Docket Number:	07-AFC-06C
Project Title:	Carlsbad Energy Center - Compliance
TN #:	203327
Document Title:	Project Owner's Supplemental Response to Data Request Set 3 (No. 76)
Description:	N/A
Filer:	Dee Hutchinson
Organization:	Locke Lord LLP
Submitter Role:	Applicant Representative
Submission Date:	11/13/2014 10:02:25 AM
Docketed Date:	11/13/2014

Re: Carlsbad Energy Center Project Petition to Amend (07-AFC-06C)
Supplemental Response to Data Request Set 3 (No. 76)
(Revised Response to Data Request 76)

Supplemental Response to Data Request 76

(Revised Response to Data Requests 76)

FIGURE DR76-1c
NCTD Rail Corridor Cross Section
Carlsbad Energy Center Project
Carlsbad, California (07-AFC-06C)
Petition to Amend

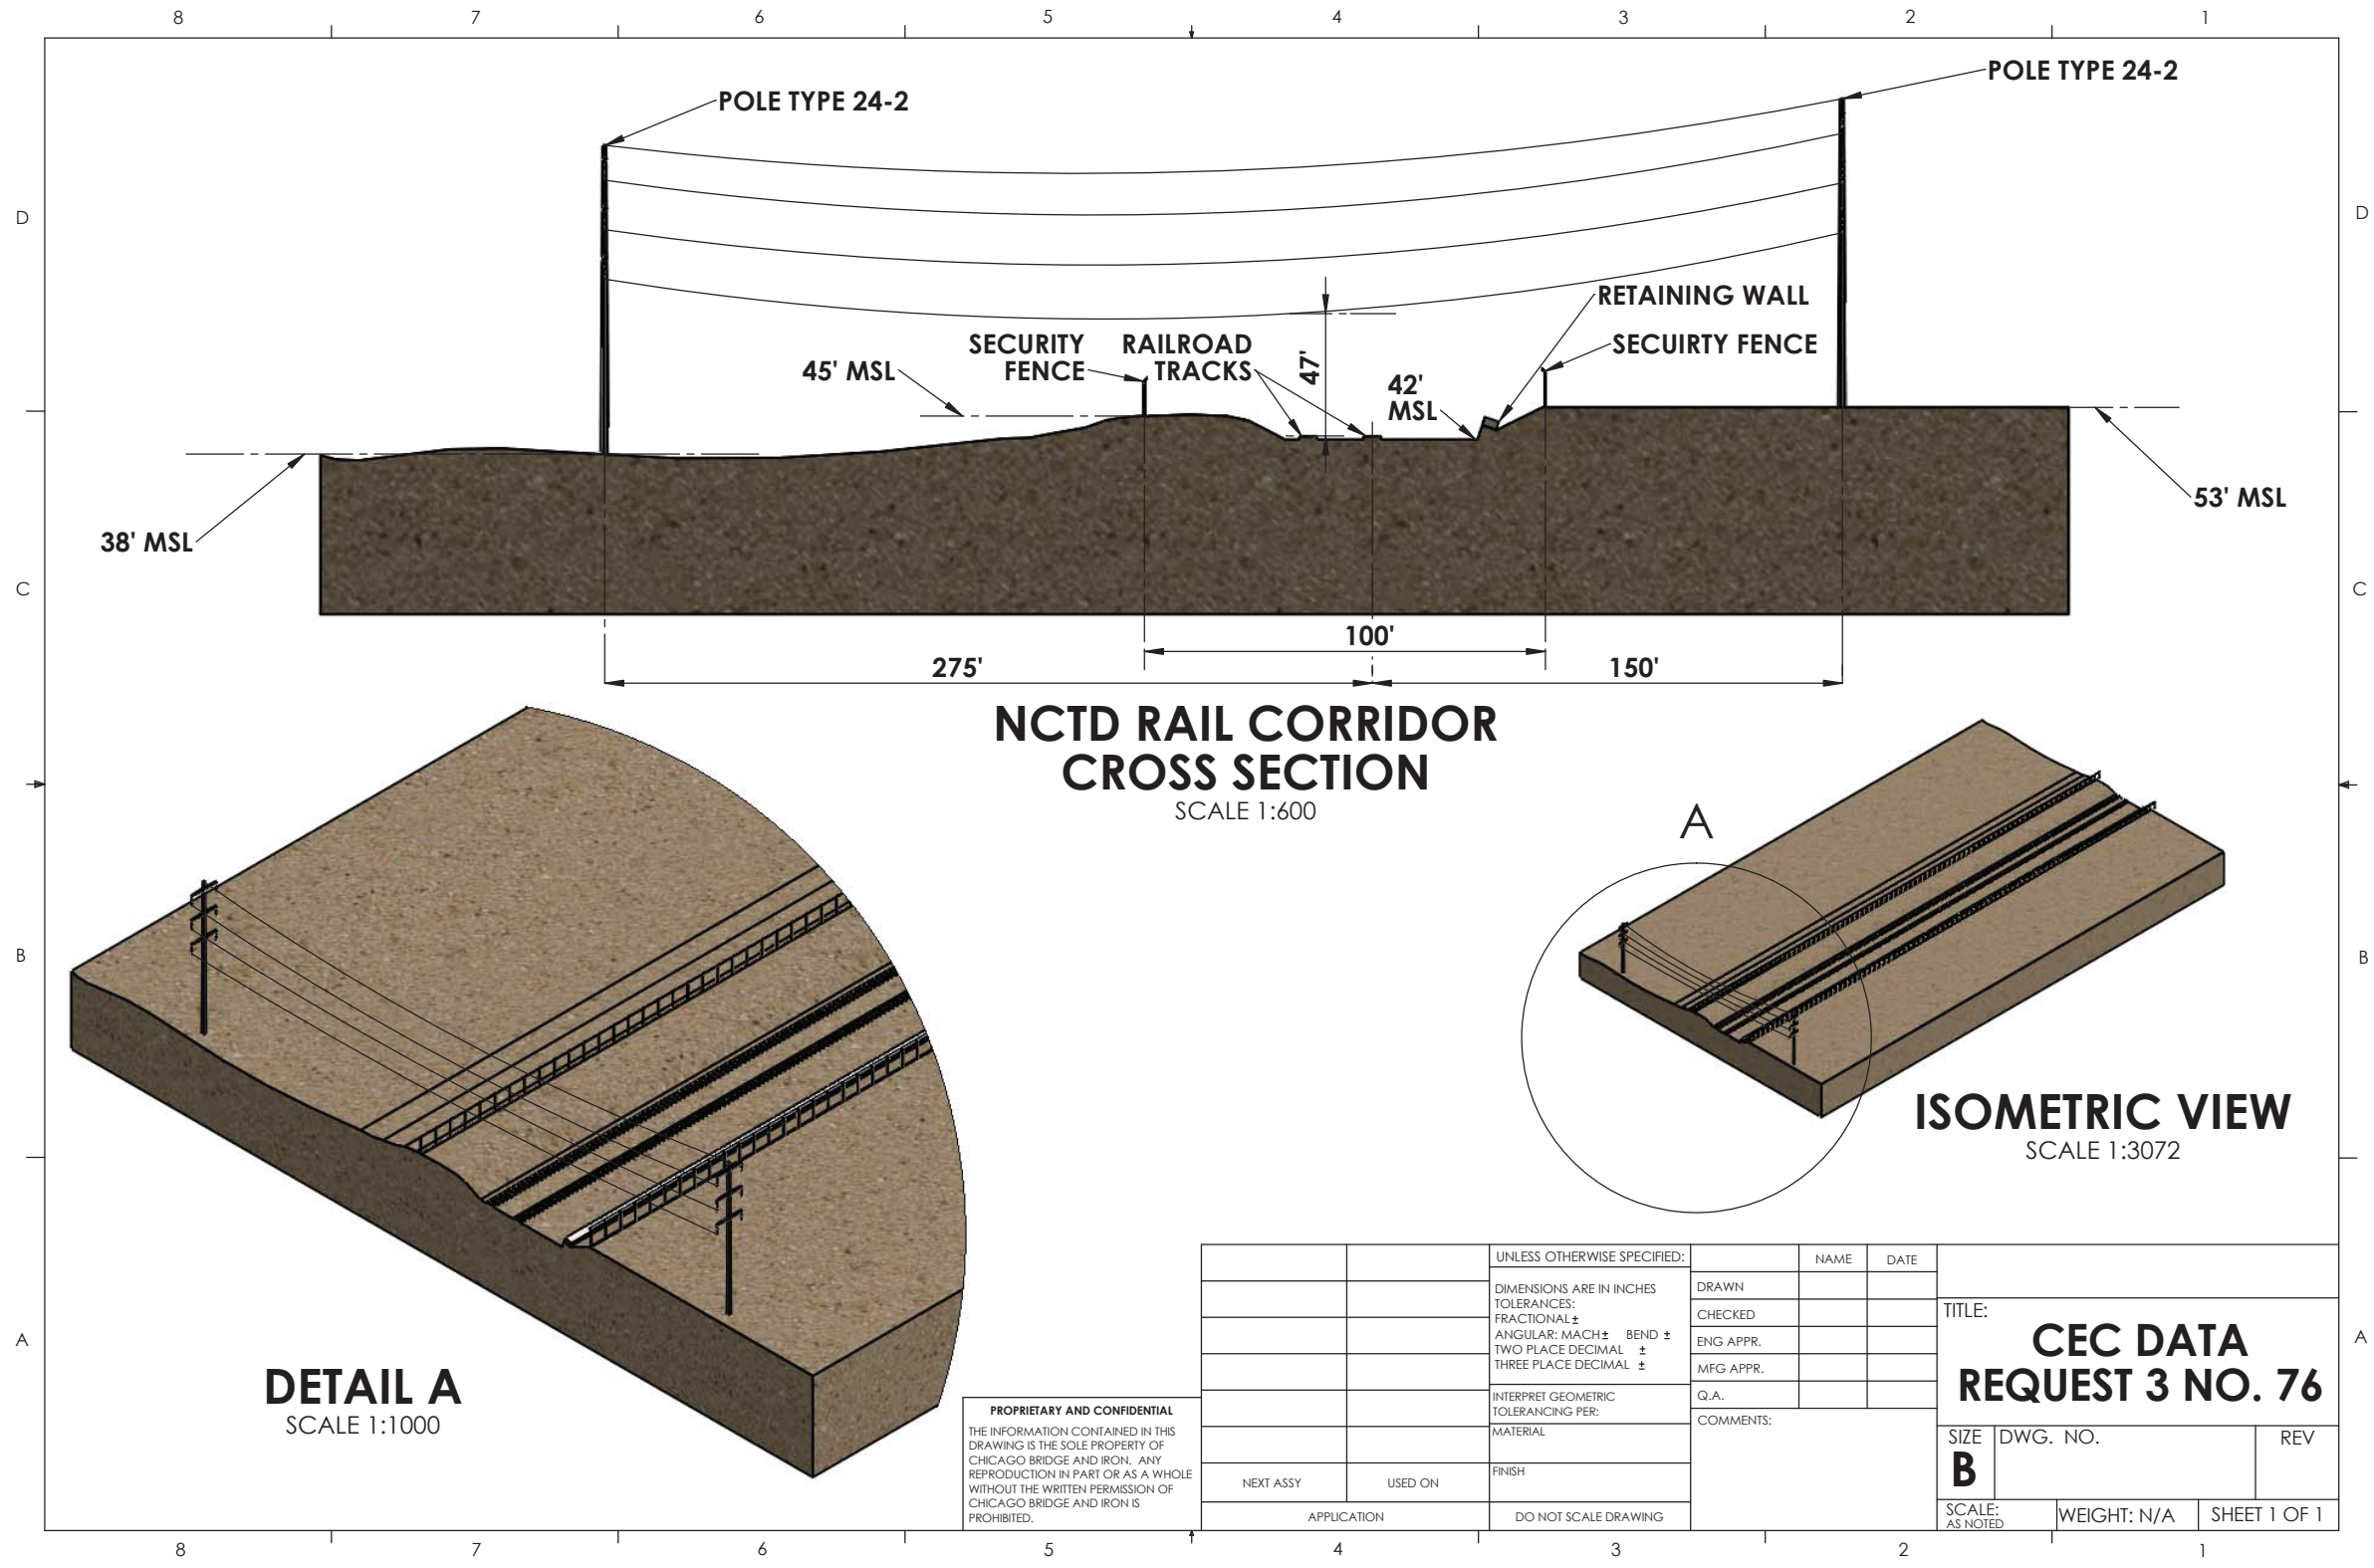
After the response to DR 76 was docketed on October 31, 2014, the Applicant noted that two preliminary versions of the Figure DR76-1a and Figure DR76-1b were inadvertently presented. The final correct version of the figure is presented in this revised response as Figure DR76-1c.

FIGURE DR24-2R2
Transmission Line Pole Cross Section
Double-circuit Configuration Steel Pole
Carlsbad Energy Center Project
Carlsbad, California (07-AFC-06C)
Petition to Amend

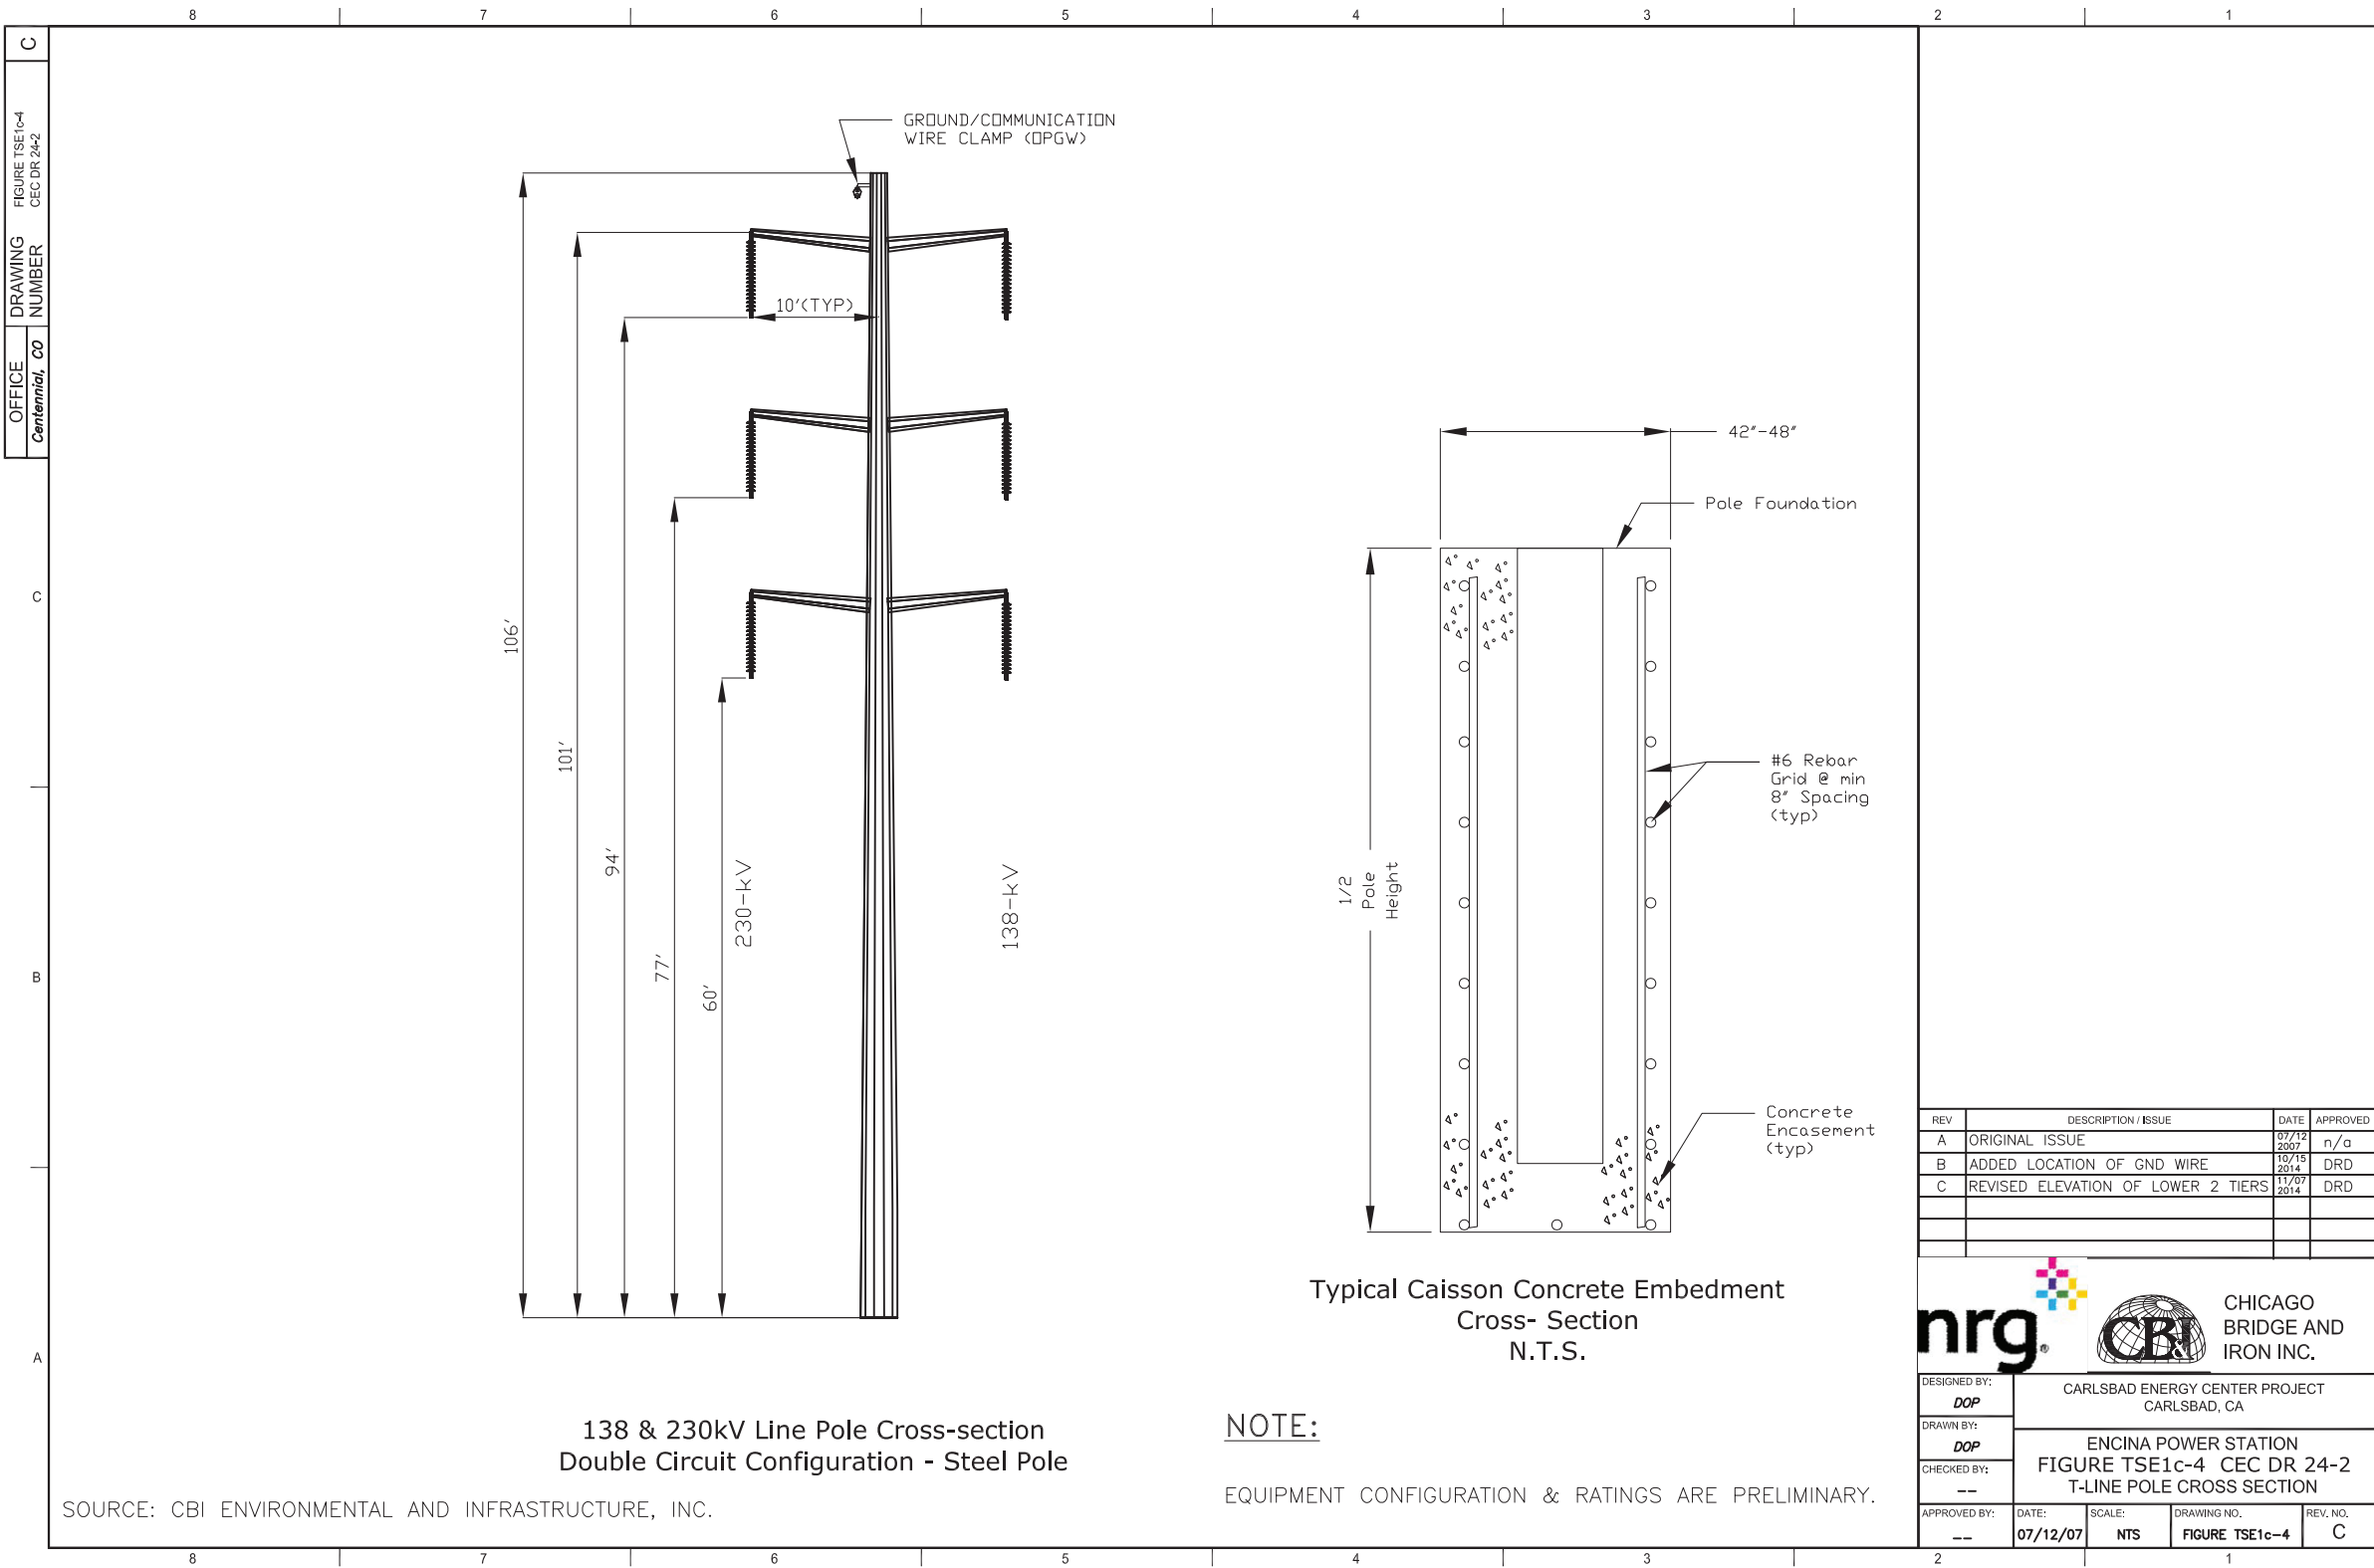
In review of this Figure DR DR76-1c, the Applicant noted two of the heights to the top conductor were incorrectly represented in Figure DR 24-2R1. The enclosed Figure DR 24-2R2 corrects the minor errors in the previous response to this data request.

1. Figure DR24-2R2 - Dimension to bottom of top conductor and ground at 84' has been corrected to 94'
2. Figure DR24-2R2 - Dimension to top of top conductor and ground at 91' has been corrected to 101'.
